Doc.-Number: IS67034440079 **Rev. No.:** C **Issue:** 0 **EO-Date:** 07.06.11 **Page** 1 of 7

Title: Radio Altimeter Antennas Alternate Conductive Gasket

ATA Chapter: 34

Figure 1: General Antenna Installation

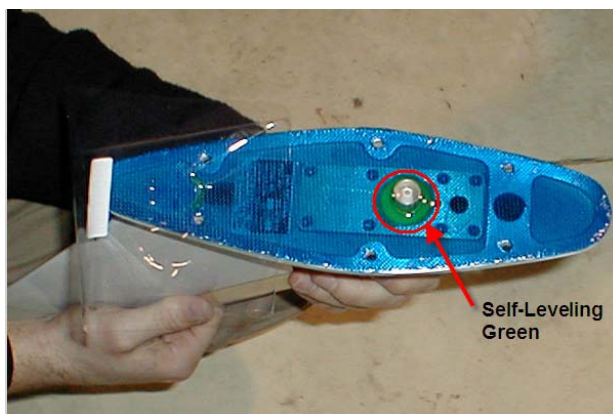
- 2.5 Apply a layer of Self-Leveling Green sealant P/N: HT3326-5-50 between gasket and antenna connector using special tool SLG application dispenser P/N: UG981108-01, as shown on figure 1.
- 2.6 Wait at least 30 minutes before installing the antenna to let enough time for the Self-Leveling Green sealant to gel.

Figure 2: General Antenna installation

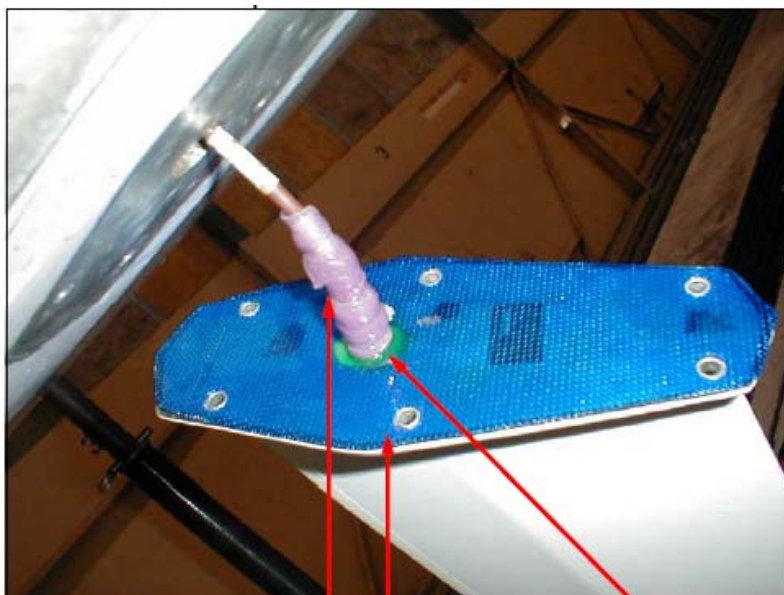
- 4.1 Remove the StretchSeal Tape P/N: AD89503-01-36 from the package and unroll a small length of tape. Pull back a small amount of the release film, making sure that the tape remains free of dirt or other contaminants.
- 4.2 From the inside of the aircraft, wrap the sticky side of the sealing tape around the mated connector with a 50% overlap while stretching it to ensure a tight wrap. Remove release film as required.

A tight wrap is necessary to ensure a proper seal.

Coverage shall be at least ½" beyond coaxial cable insulation jacket to the base of the antenna.

When wrapping the sealing tape around the cable, leave the coaxial cable unconnected until the locking part of the connector is reached, and then connect the coaxial cable to the antenna.

Finish wrapping the sealing tape up to the base of the antenna.

The sealing tape will be easier to install this way. (Refer to Figure 2)

- 4.3 Apply cable ties (MS 3367 type) at each end of tape. Use minimum tension on cable tie installation tool (Ref. to Figure 2).
